ADDENDUM NO. 01 June 24, 2025

To Drawings and Specifications dated June 10, 2025.

PKG 3A – GPHS New Fieldhouse

Prepared by:	PBK
	11 Greenway Plaza, 22 nd Floor
	Houston, TX 77046-1104
	PBK Project No: 240539

OVERALL ROOF PLAN

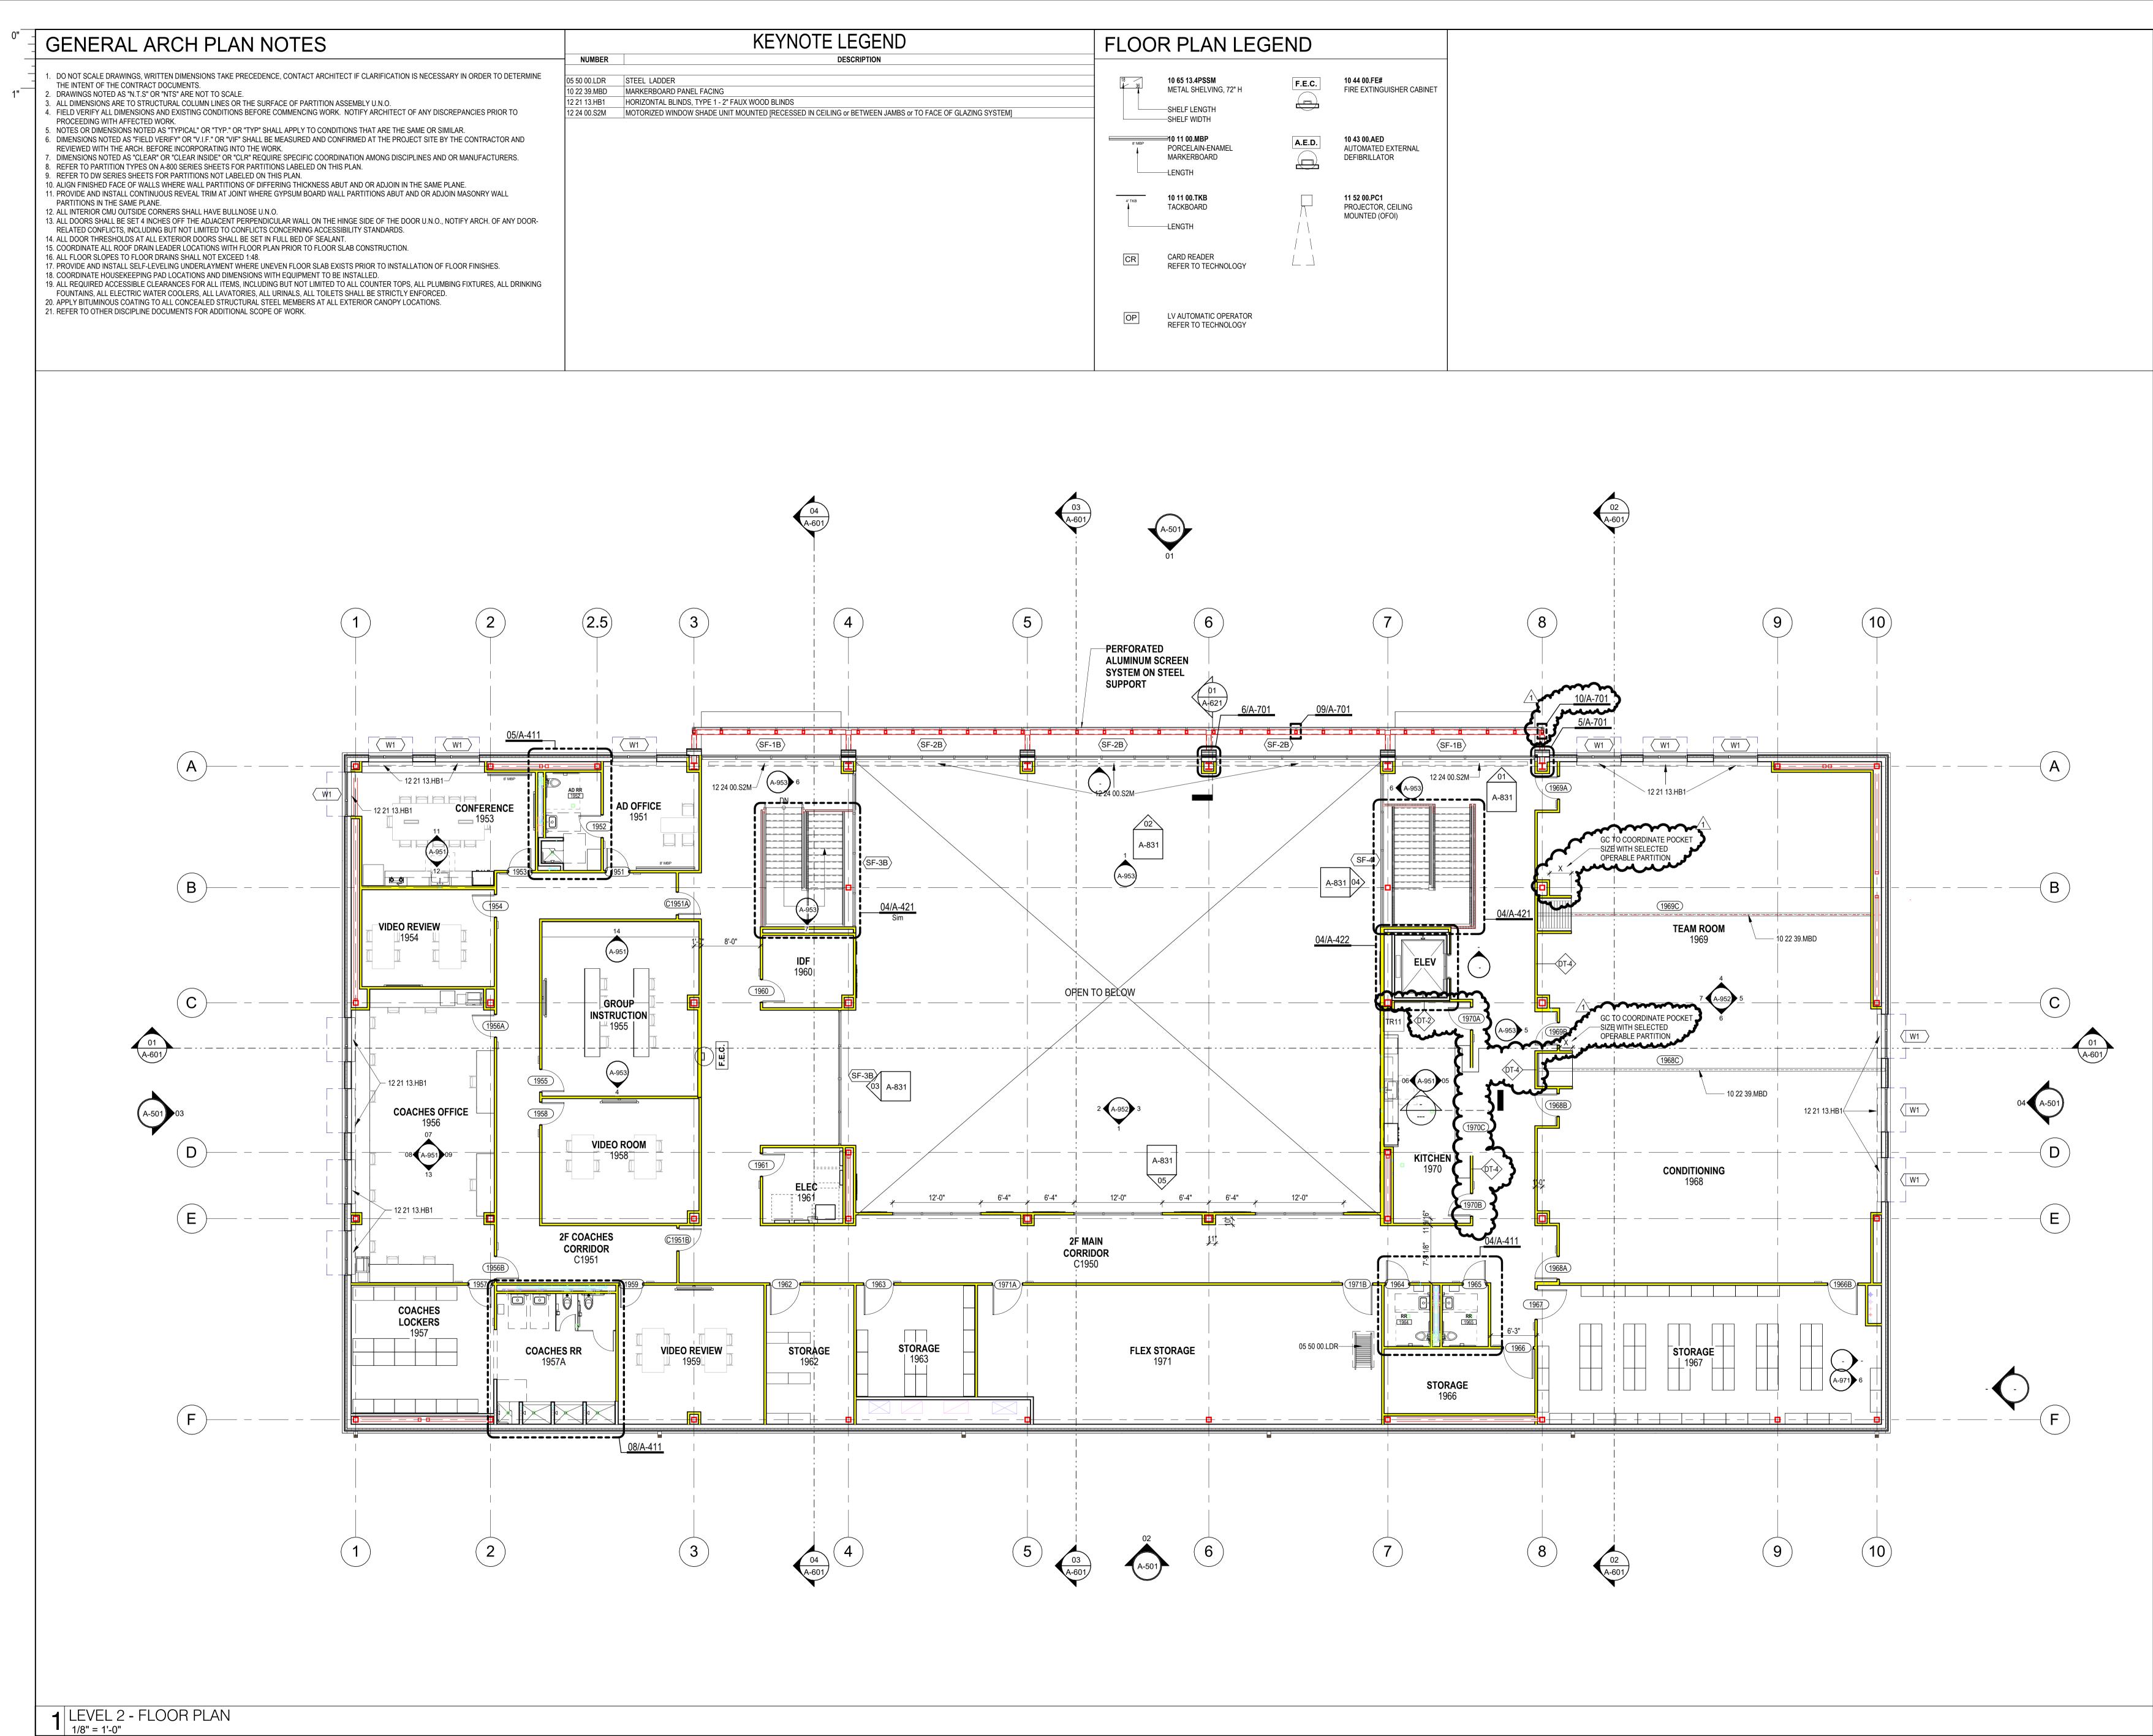
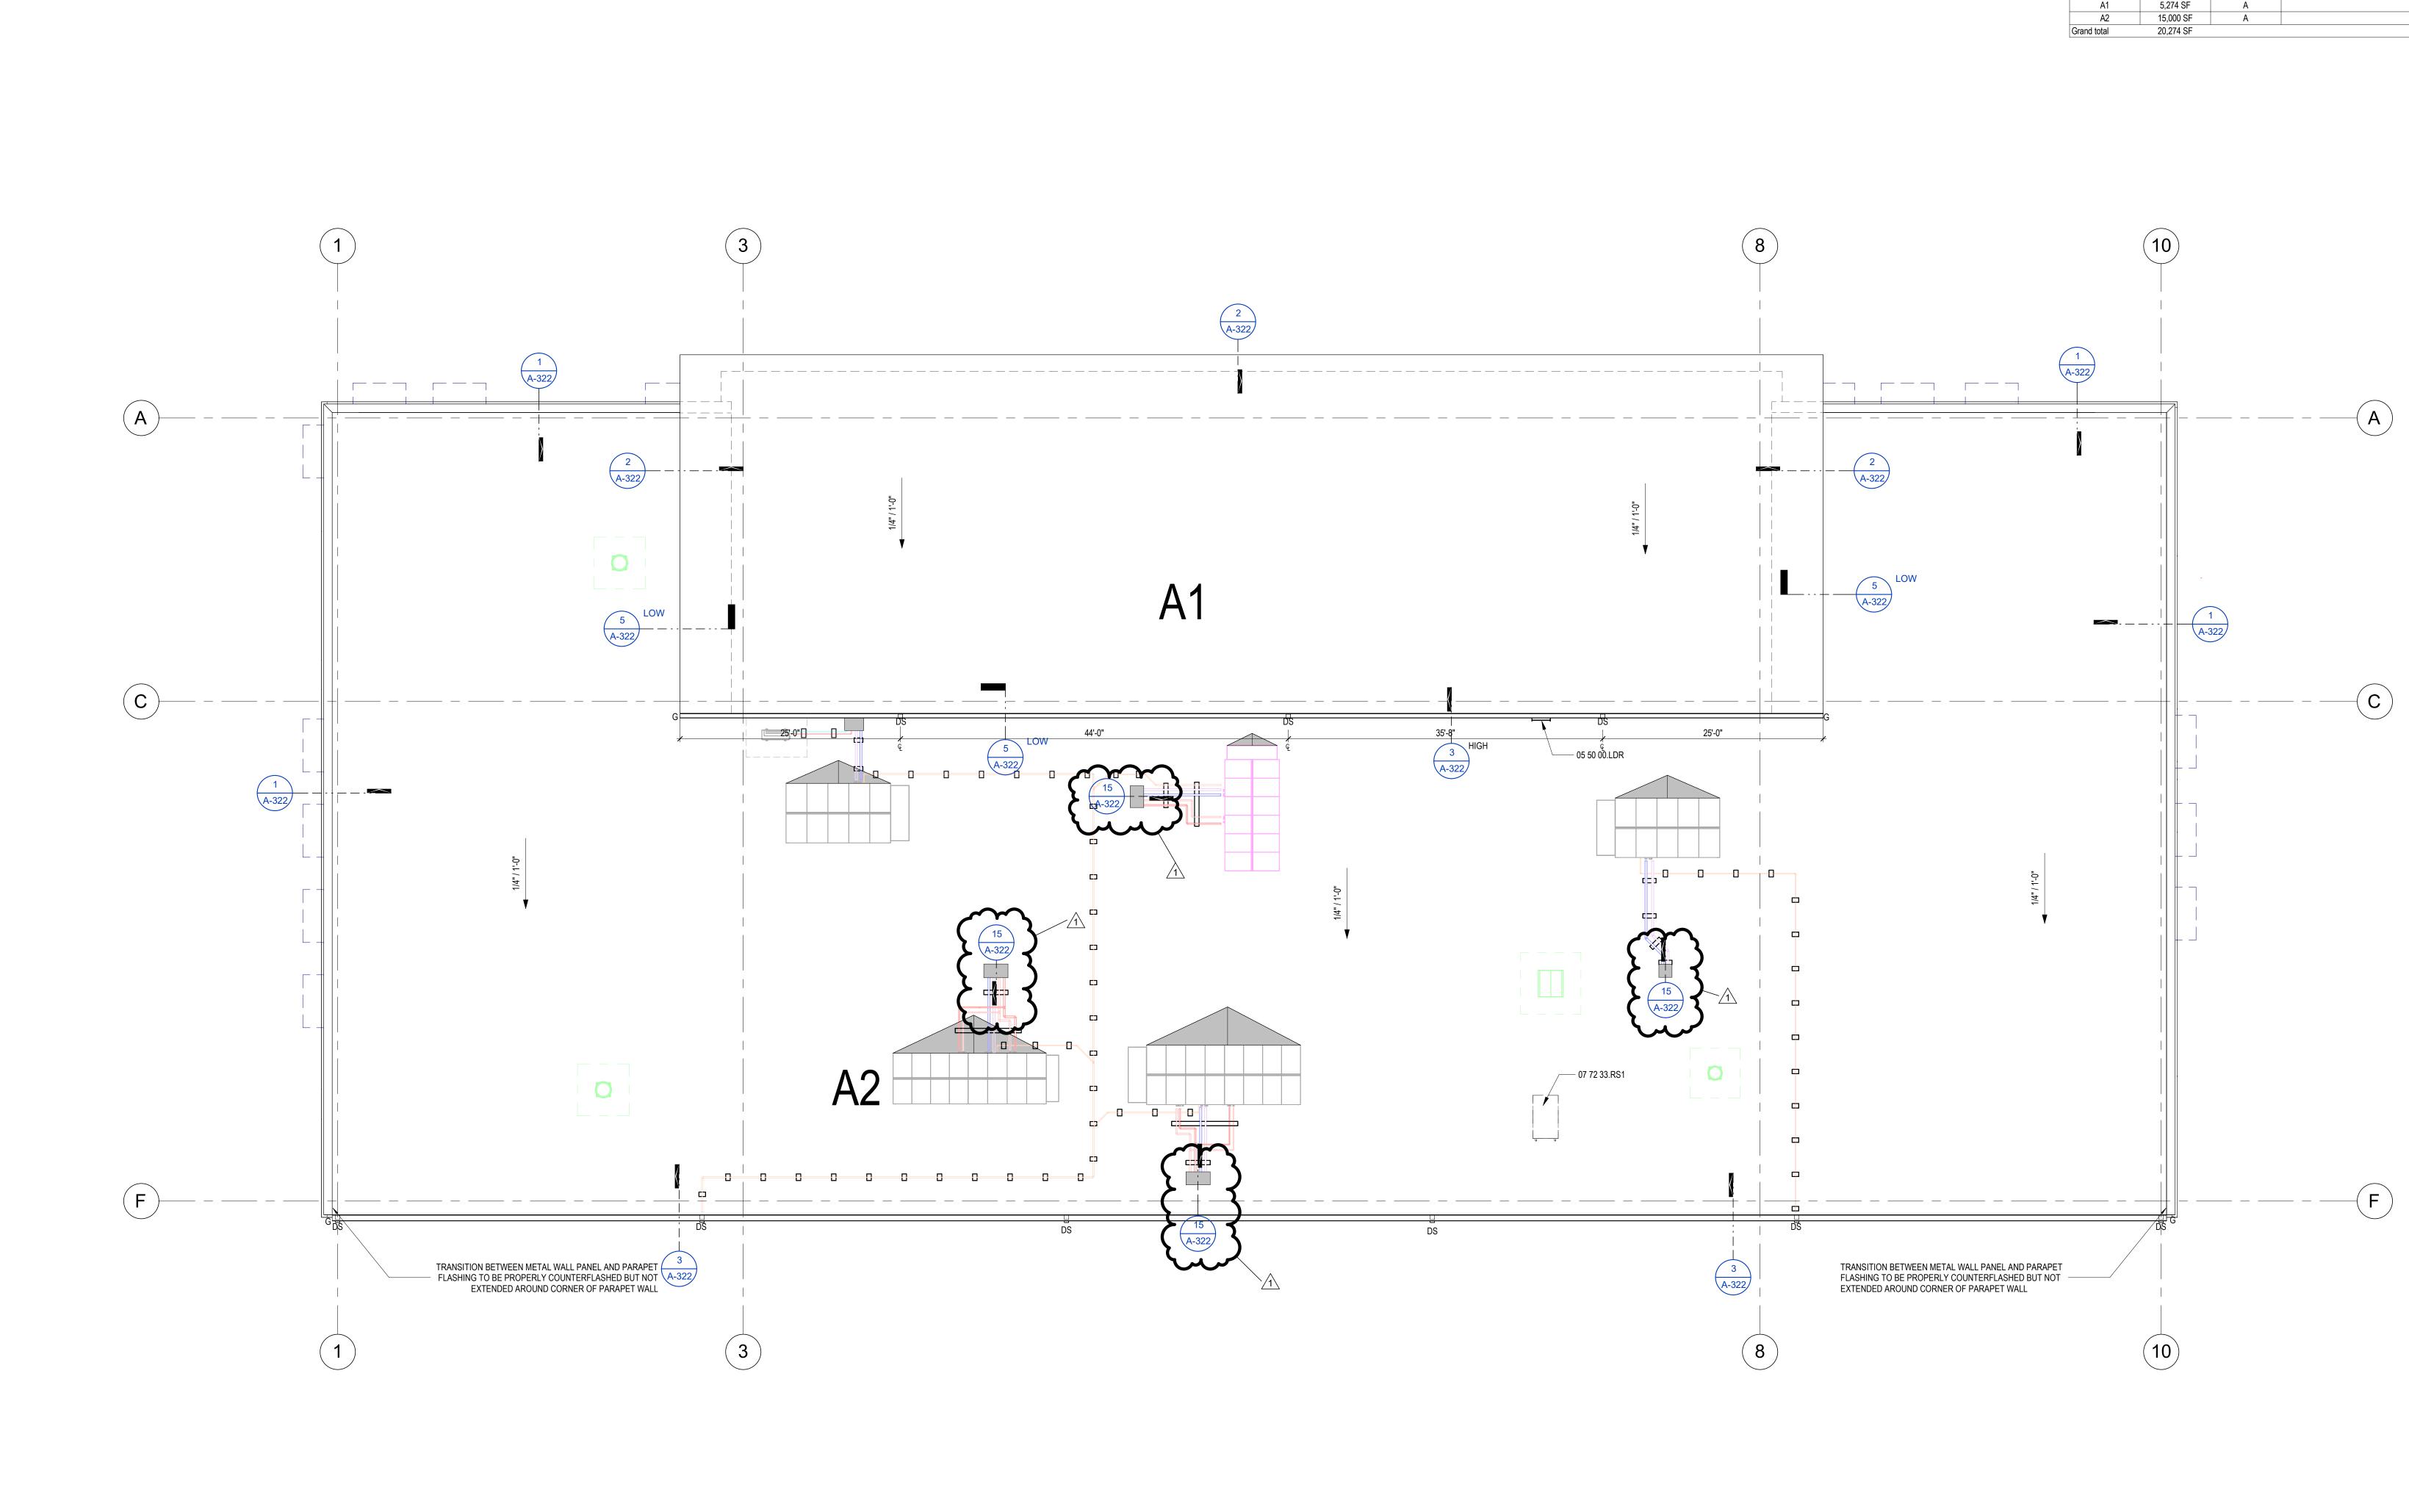
Item No. 05 A-301 OVERALL ROOF PLANS

A. Callouts to 15/A-322 added to roof plan

A-422

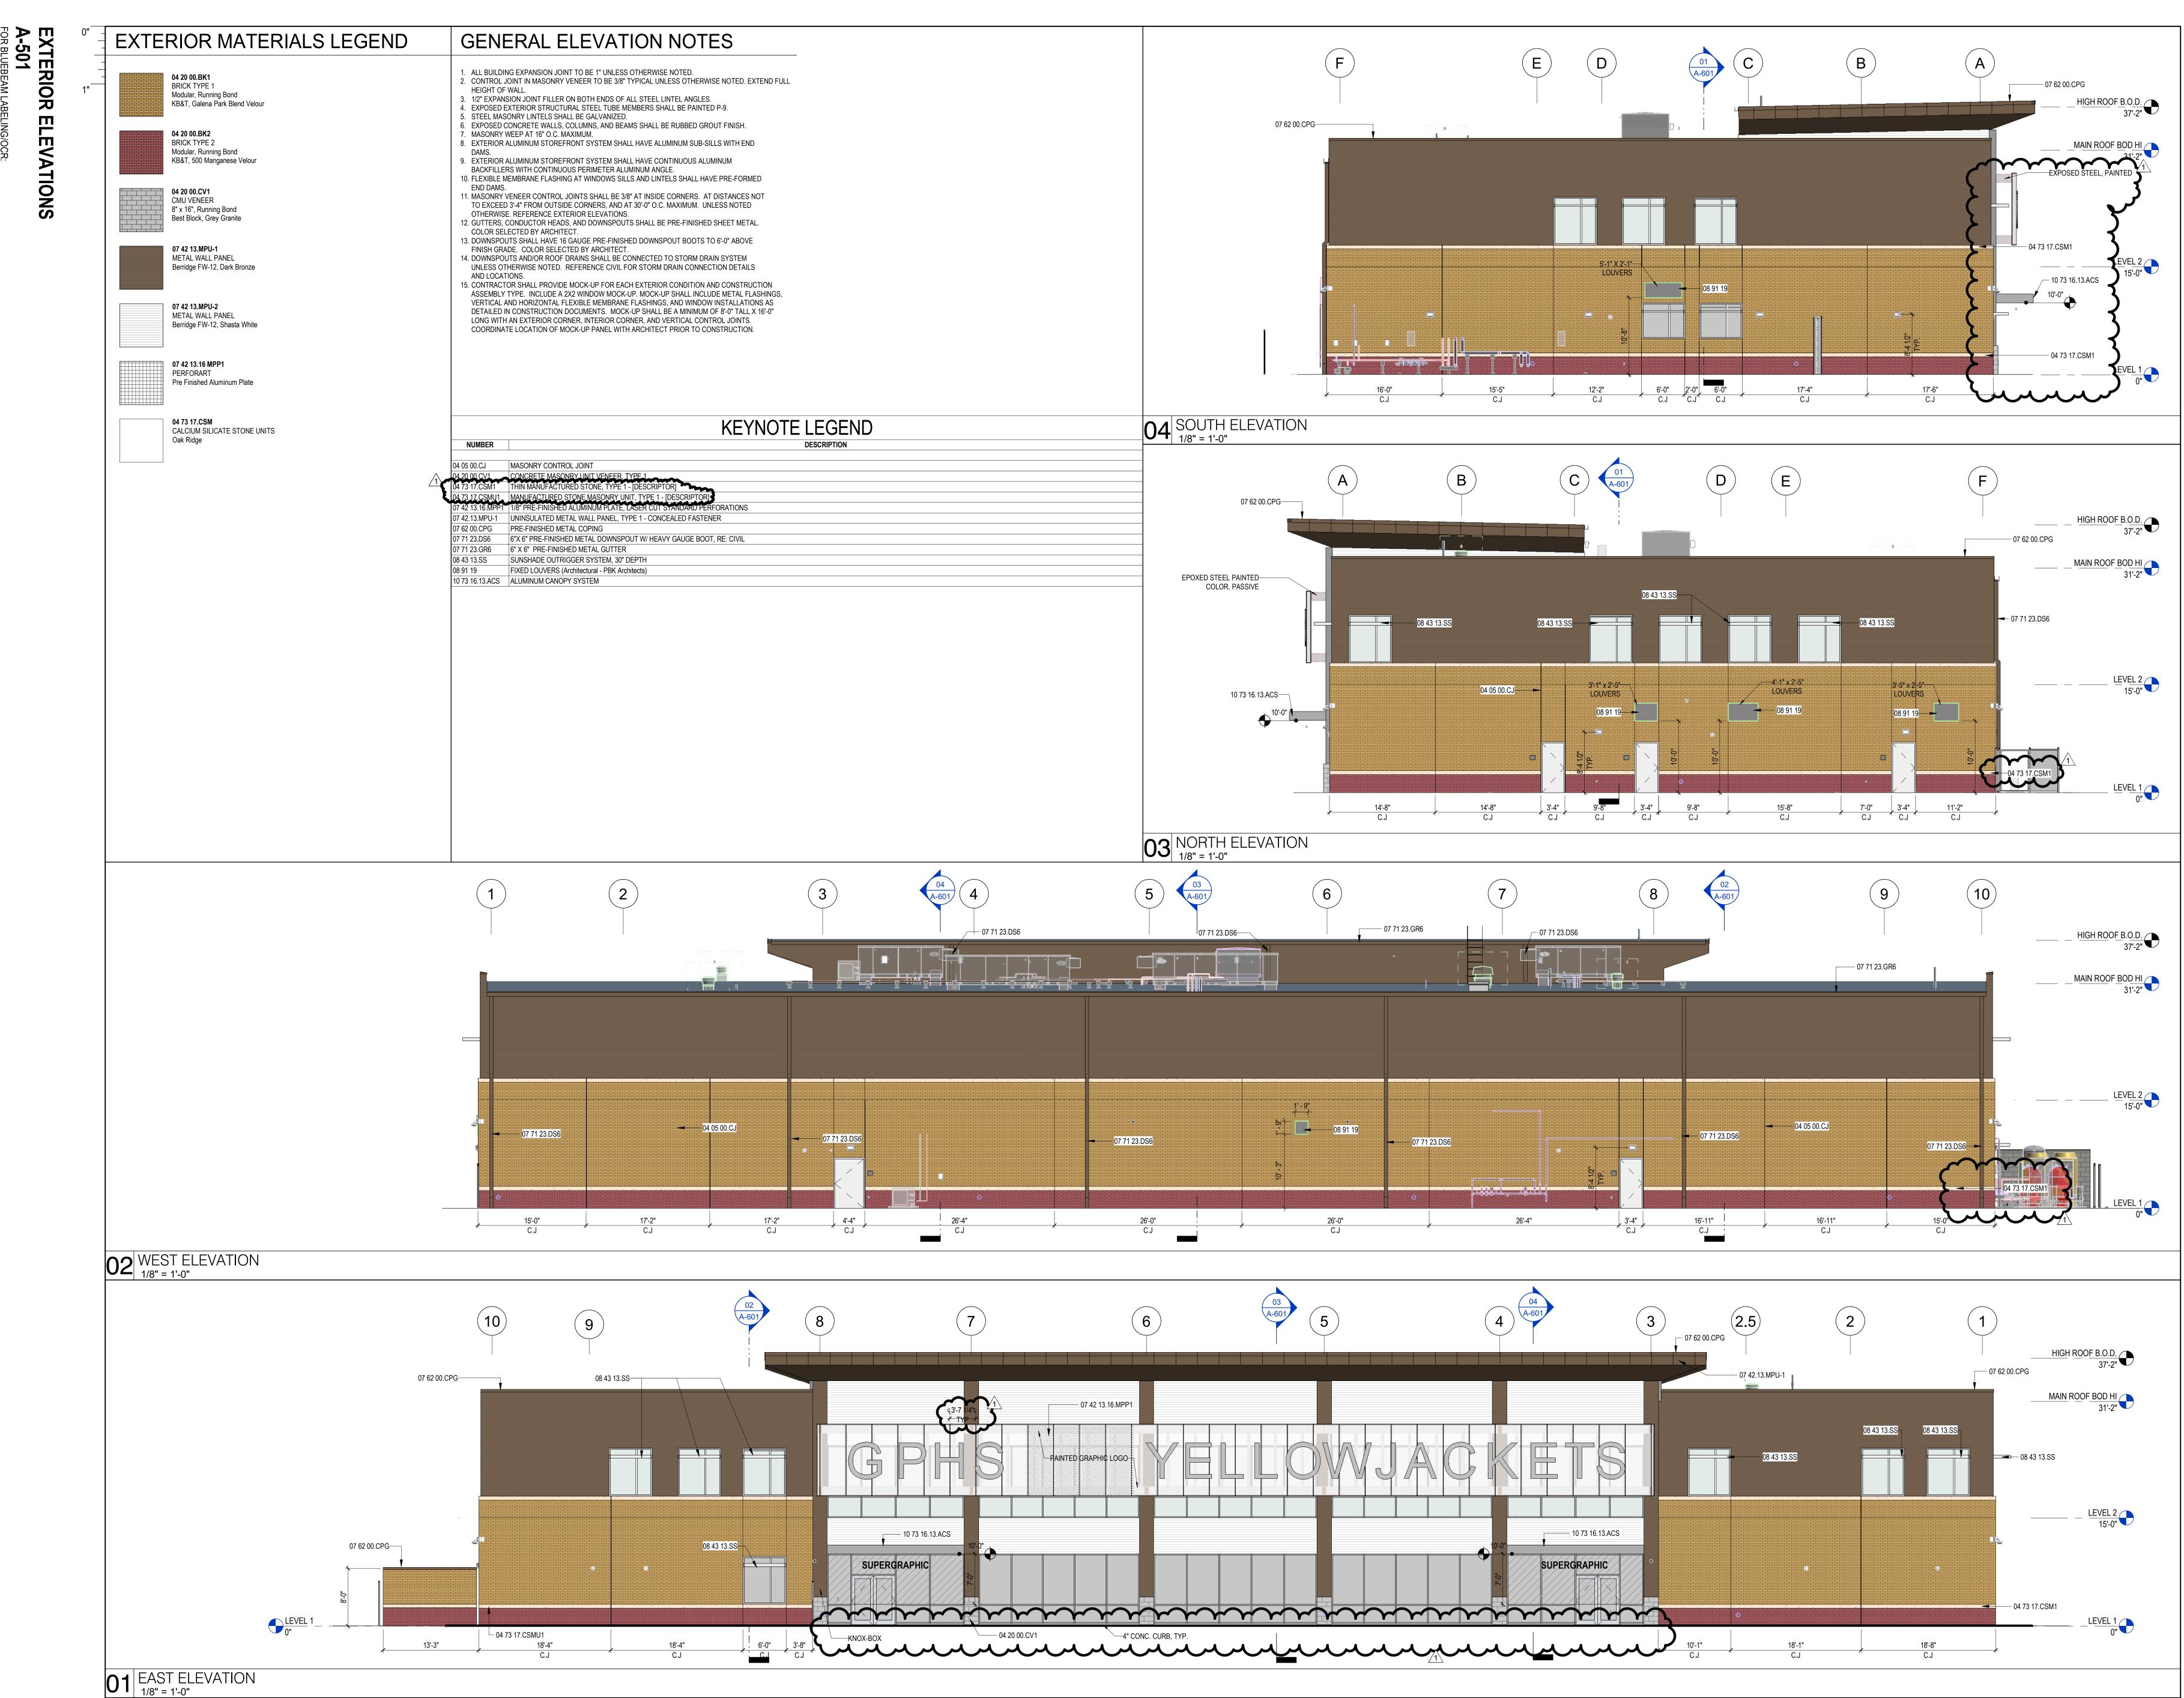
- A-422 ELEVATOR PLANS & SECTIONS
 A. Added DT-2 partition at south side of elevator.
- B. Added callout for detail 10/A-851.
- C. Revised notes and on detail 03.
- D. Added detail 06.
